NAVY ELECTRONICS LAB SAN DIEGO CALIF
EVALUATION OF BATHYTHERMOGRAPH MODELS OC-1C/S AND OC-2C/S.(U)
JAN 58 J E ROBERSON
NEL-827

EVALUATION REPORT,
REPORT 827

EVALUATION OF BATHYTHERMOGRAPH MODELS OC-1C/S AND OC-2C/S.

Evaluate preproduction samples of surface-vessel bathythermograph models OC-1C/S and OC-2C/S for compliance with specifications.

Figure 1. PP-1 Calibration trace.

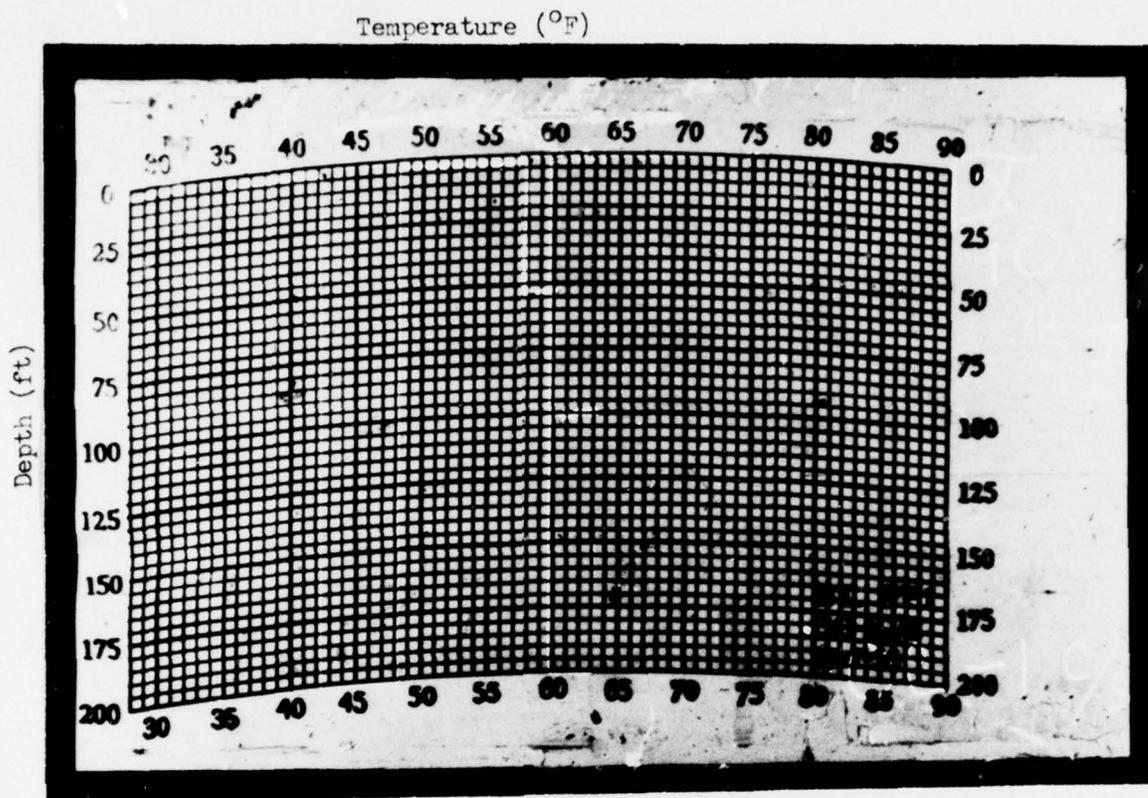
1. The layout of both the PP-1 and PP-2 grids is good. However, the PP-1 (fig. 1) must be considered unacceptable because the lines, which vary in width from 0.0025 to 0.0045 inch, are much too wide for reading to 0.1°F. The calibration trace is nearly hidden. Wide grid lines can be caused by wide harp lines, shadows, or overexposure.

1. Make grid lines 0.0015 inch wide or less, except for the periodic heavier lines, which should not exceed 0.003 inch in width. Improve the grid-making apparatus to give the thin lines without extreme underexposure.

Figure 2. PP-2 Sea trial trace.

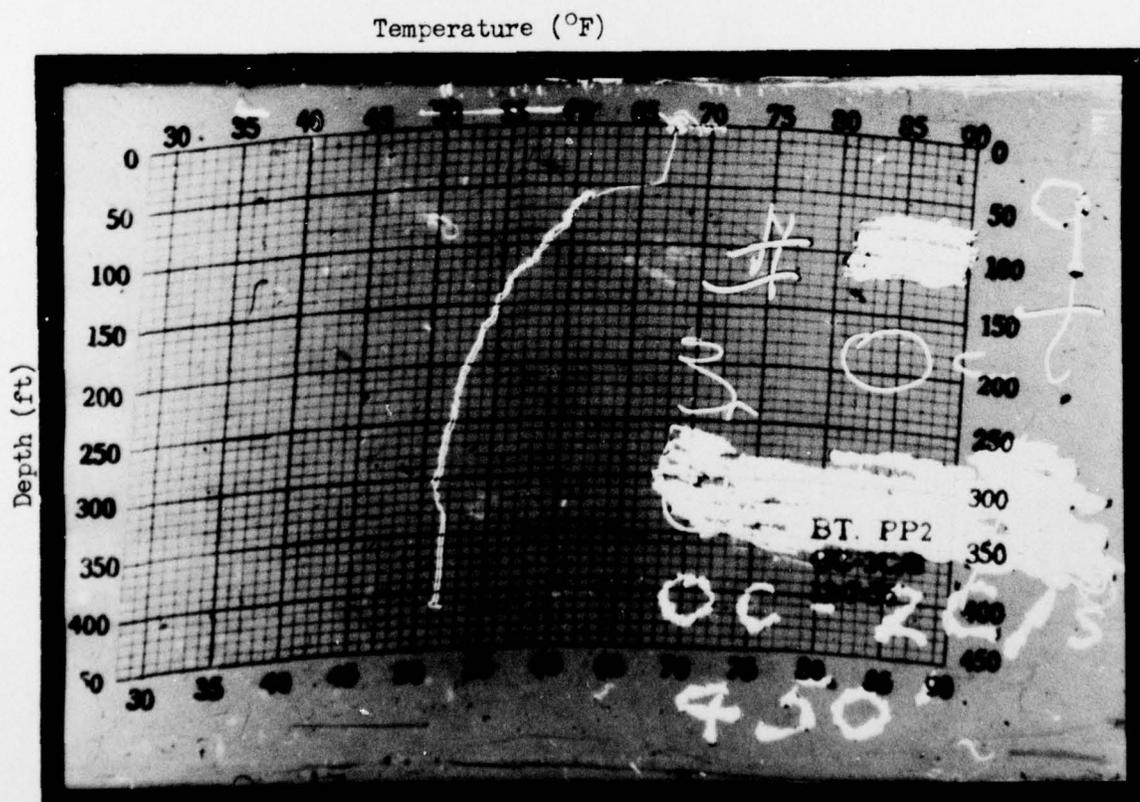
The PP-2 grid (fig. 2) is satisfactory; its lines are thin (0.002 inch and less) as a result of underexposure. In the interest of accuracy, it is preferable to err on the thin side rather than the thick, and underexposure is a means to this end. However, the grid-making apparatus should be improved to make thinner lines without underexposure. The names of the grid units should be applied to both axes when there is room.

The traces of figure 2 have about 0.3°F hysteresis. The trace of decreasing depth is marred by stylus

vibrations excited from the ship, cable, and currents of water around and through the BT. Figure 2 is representative of a BT in good working order.

Figure 3. PP-2 Calibration trace

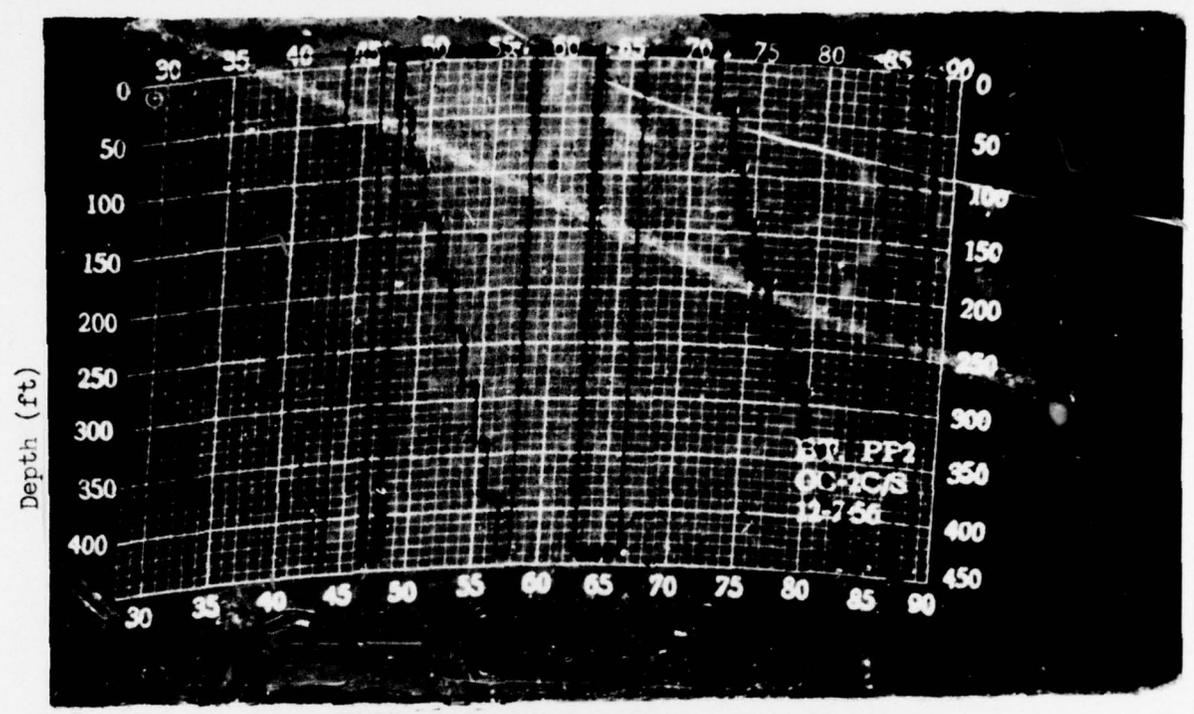
After the adjustment the calibration was checked from the trace of figure 3 and another trace, and plotted in figure 6. (The slide and grid were not properly aligned when figure 3 was taken.) Test No. 1 was conducted with increasing temperature and Test No. 2 with decreasing temperature. The plot shows the average error after correcting for the 3°F adjustment. The original temperature calibration did not meet the specification because the error varied over a span of 1.2°F between 30° and 90°F. The depth errors were 2 feet and less, meeting the 1 per cent limit of 4.5 feet. The pen lifter operated at 60 feet. Hysteresis data were not obtained during calibration because of the close test scheduling. The sea trials and pressure-element tests give some hysteresis information, and the vertical spread of the points in figure 6 indicates the variation of temperature error for repeated measurements.

of the finite stylus point curvature. If the stylus is too dull for the coating, the smoke will build up in front of the stylus, hindering it and frequently producing a very wide trace. The smeared traces of figure 3 show what can happen, although this case was aggravated by the antifreeze in the calibration water. A thick coating requires more skunk oil, which makes buildup more likely. Also, a thick coating tends to flake like a thick coat of paint. A thin coating has the advantages of a sharper trace, less hysteresis because of less friction, and less buildup. The thin coating reduces the contrast for photography. However, it is much better to get a fair photo of a good record than to get a good photo of a poor record. The best coating is the thinnest that meets minimum requirements for reading and photographing.

Use as light a smoke coating on the slides as can be photographed by the standard procedures. Avoid excessively greasy smoke and excess skunk oil.

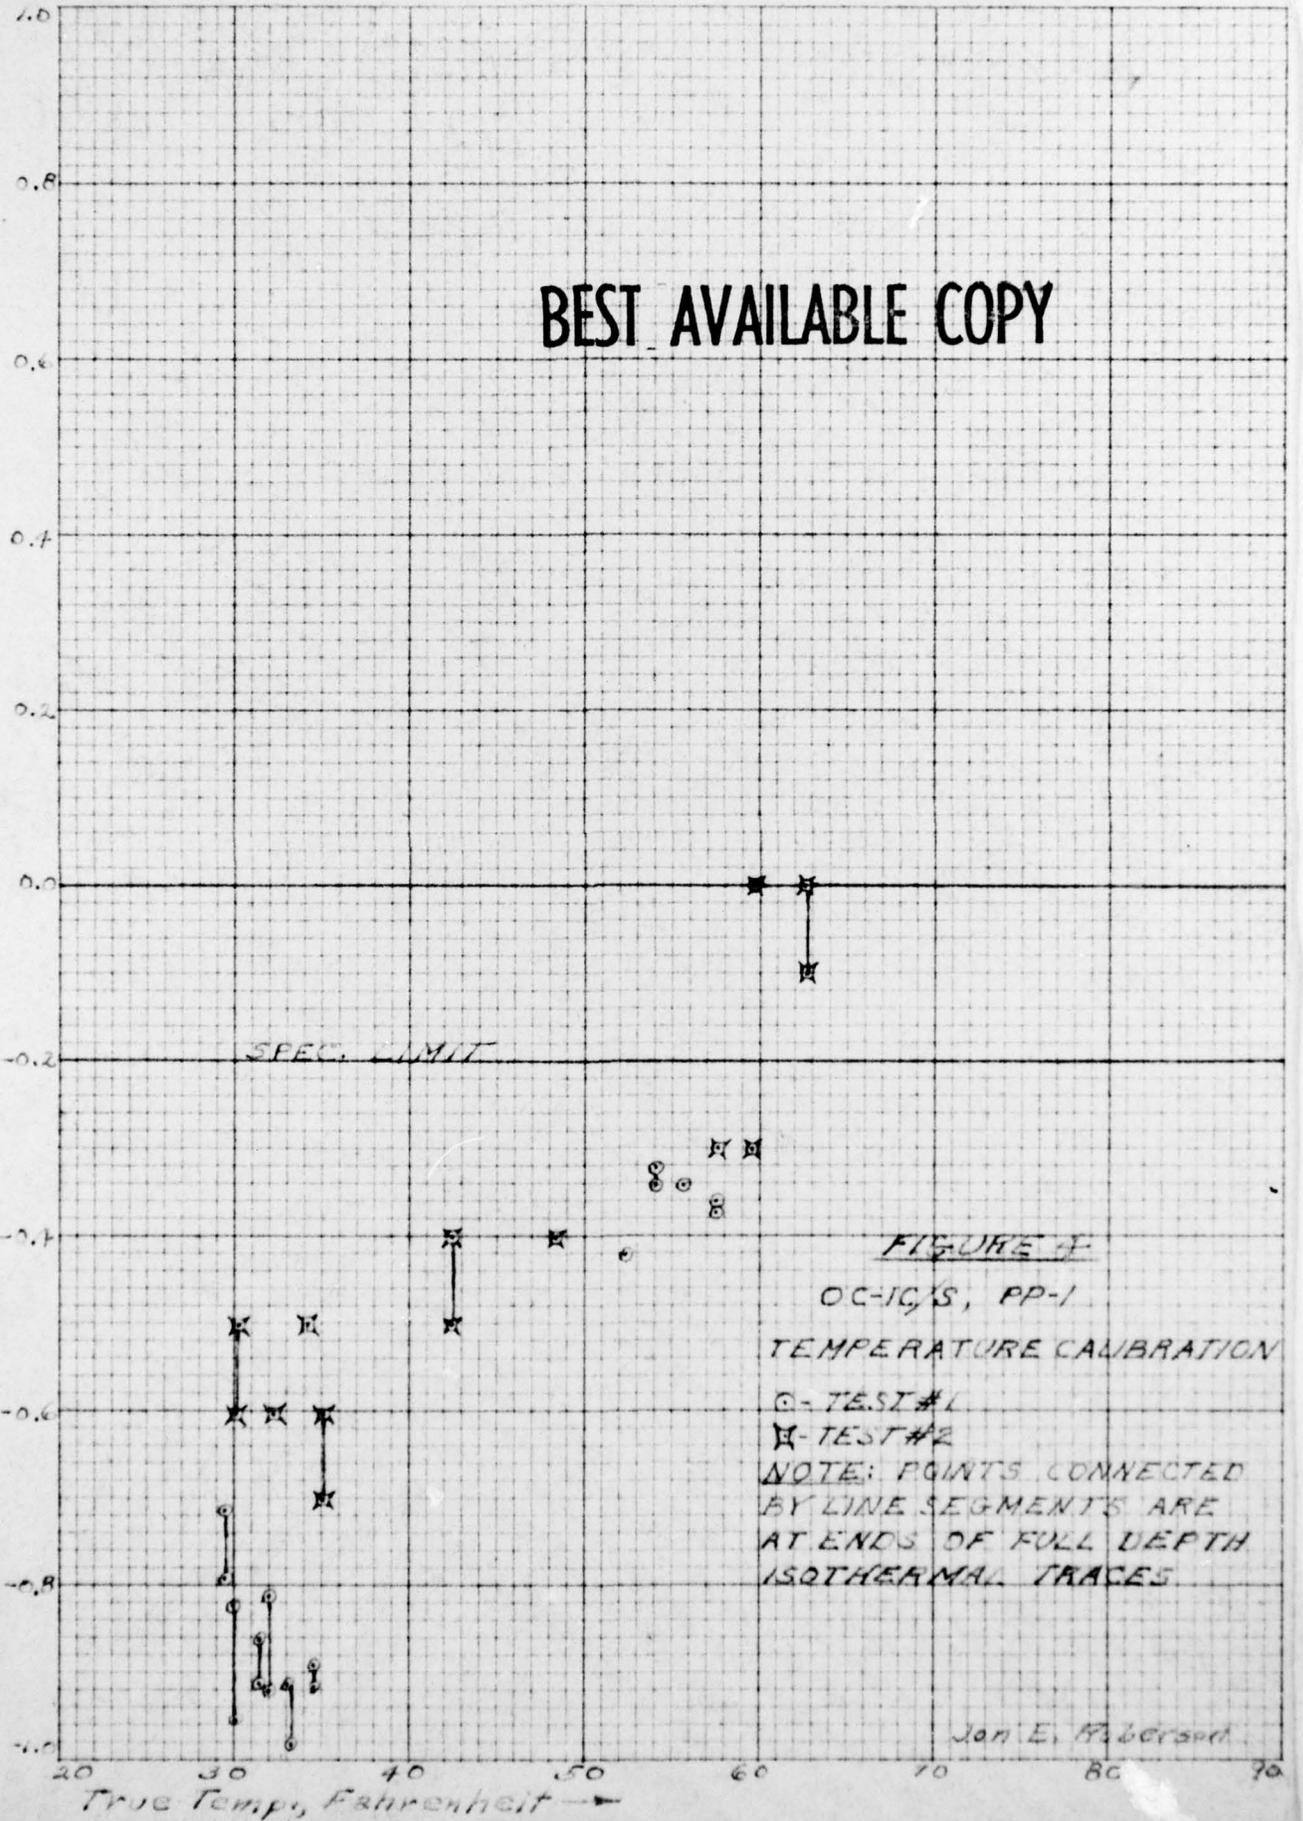
The two tests of the PP-1 produced traces similar to figure 3. Both tests were interrupted by failures of two successive immersion heaters. Figures 4 and 5 show that the temperature and depth errors exceed the specification limits of 1 per cent of full depth and 0.2°F between 34°F and 90°F. The average errors for the two tests vary by 0.3°F and 1.5 feet of water. The stylus probably suffered a change of adjustment between tests. The pen lifter operated at 60 feet as required by the specification.

The factory calibration errors appear as systematic variations over the grid range. Figures 4 and 6 show

similar slopes, indicating calibration error. The vertical line segments indicate isothermal traces on the temperature calibration plots. The isotherms read from 0.1 to 0.2 higher at full depth than at sea level in four out of seven cases for PP-1 and six out of seven cases for PP-2. This was probably caused by stylus flexure. The slope of figure 5 suggests a linear calibration error. The systematic errors are more serious than the average errors because they change the shape of the traces and cannot easily be corrected.

1. Improve the temperature calibration to eliminate the variation of temperature error with temperature shown by figures 4 and 6.

FIGURE 5

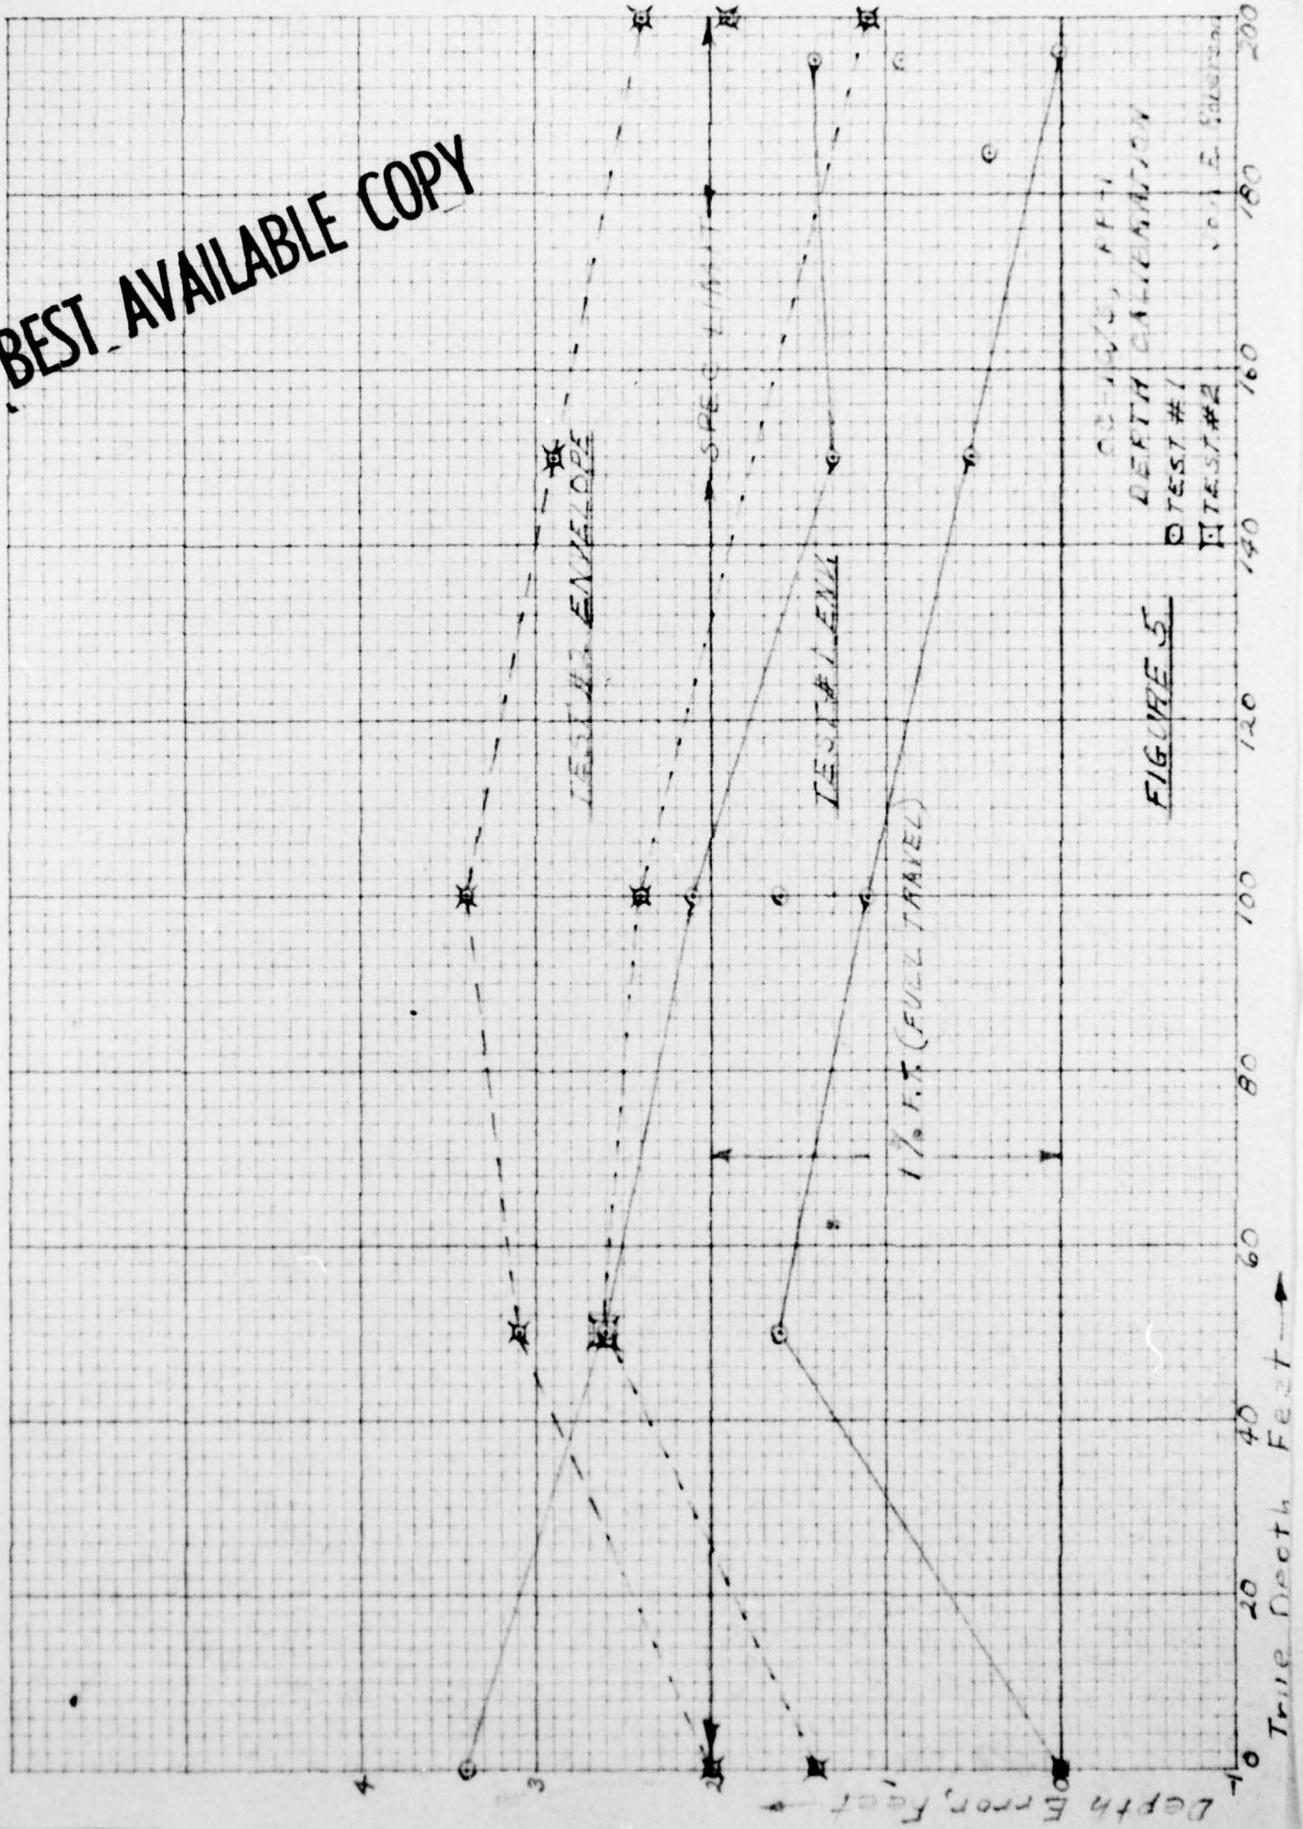
It is important to note that the effective weight of the moving parts of the PP-1 element is sufficient to cause a 2.8-foot depth error merely by inverting the element. This fact suggests that the depth errors of figure 5 are greater by 1.4 feet because the sample BT's were calibrated in the nose-down position instead of the horizontal towing position. If this correction is applied, the PP-1 depth calibration in figure 5 meets the 1 per cent requirement.
